# INTERNATIONAL STANDARD

## AMENDMENT 1

**Part 3: Testing of optical fibre cabling**

[ISO/IEC 14763-3:2014/Amd.1:2018](https://standards.iteh.ai/iso/IEC/14763-3/2014/Amd.1/2018)

**Figure 1 – Relationship of related International Standards**

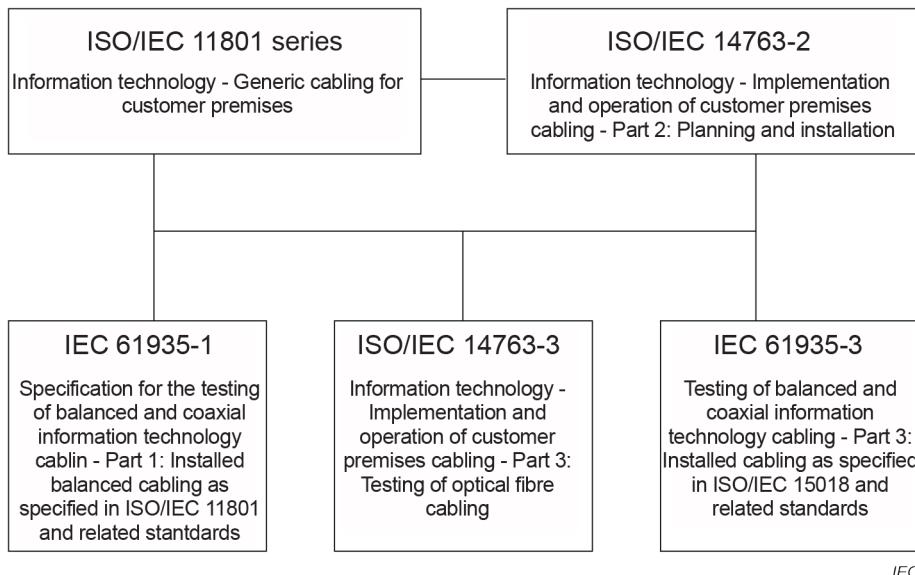
*Replace paragraphs 1 to 3, including Figure 1, with the following:*

Figure 1 below shows the inter-relationship between the ISO/IEC 11801 series and other International Standards and for cabling systems with related standards.

NOTE ISO/IEC 15018 has been replaced by ISO/IEC 11801-4.

Figure 8 – Connection of LS – LTC – Near end EQP cord – PM for reference setting

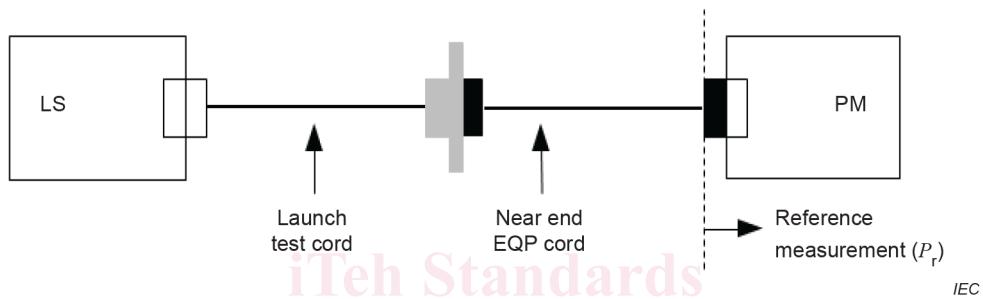
Replace 9.1.1.2 with the following:

a) Connect the launch test cord (LTC) to the light source (LS) at one end and to the equipment (EQP) cord at the other end. Connect equipment cord to the power meter (PM). Allow sufficient time for the light source stabilization in accordance with light source manufacturer's recommendations. (See Figure 8). Since this reference measurement is carried out with a near end EQP cord, the defect of near end EQP cord may not be found. When this test method is used, the quality of the near end EQP cord shall comply with the requirement.
